Application No.	Applicant(s)					
Office Action Summer	10/626,729	PATEL, VIPUL					
Office Action Summary	Examiner	Art Unit					
	Dang T. Nguyen	2824					
The MAILING DATE of this communication appears on the cover sheet with the correspondence address Period for Reply							
A SHORTENED STATUTORY PERIOD FOR REPLY IS SET TO EXPIRE 3 MONTH(S) FROM THE MAILING DATE OF THIS COMMUNICATION. - Extensions of time may be available under the provisions of 37 CFR 1.136(a). In no event, however, may a reply be timely filed after SIX (6) MONTHS from the mailing date of this communication. - If the period for reply specified above is less than thirty (30) days, a reply within the statutory minimum of thirty (30) days will be considered timely. - If NO period for reply is specified above, the maximum statutory period will apply and will expire SIX (6) MONTHS from the mailing date of this communication. - Failure to reply within the set or extended period for reply will, by statute, cause the application to become ABANDONED (35 U.S.C. § 133). Any reply received by the Office later than three months after the mailing date of this communication, even if timely filed, may reduce any earned patent te

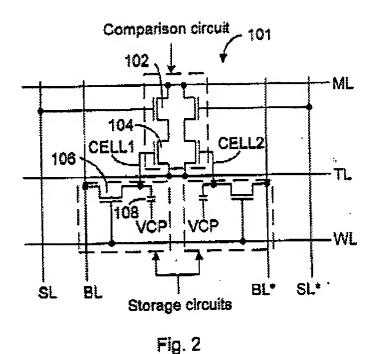
With respect to claims 1, 5, 18, 21, 28 and 35, under Remarks applicant argued: the "shieldline TL" of Gillinghan does not positioned between the matchline and the wordline; and the "shieldline TL" is being electrically separate from the matchline. Examiner respectful disagrees from the following:

Fig. 2 of Gillinghan clearly discloses the shieldline TL is position between the matline ML and the wordline WL, and the shieldline TL is separate from the matchline ML by the electrical components 102 and 104; in other words, the electrical components 102 and 104 are using to disconnect/separate or connect the shieldline TL from matchline ML. Therefore, Gillinghan clearly discloses every aspect of claim invention.
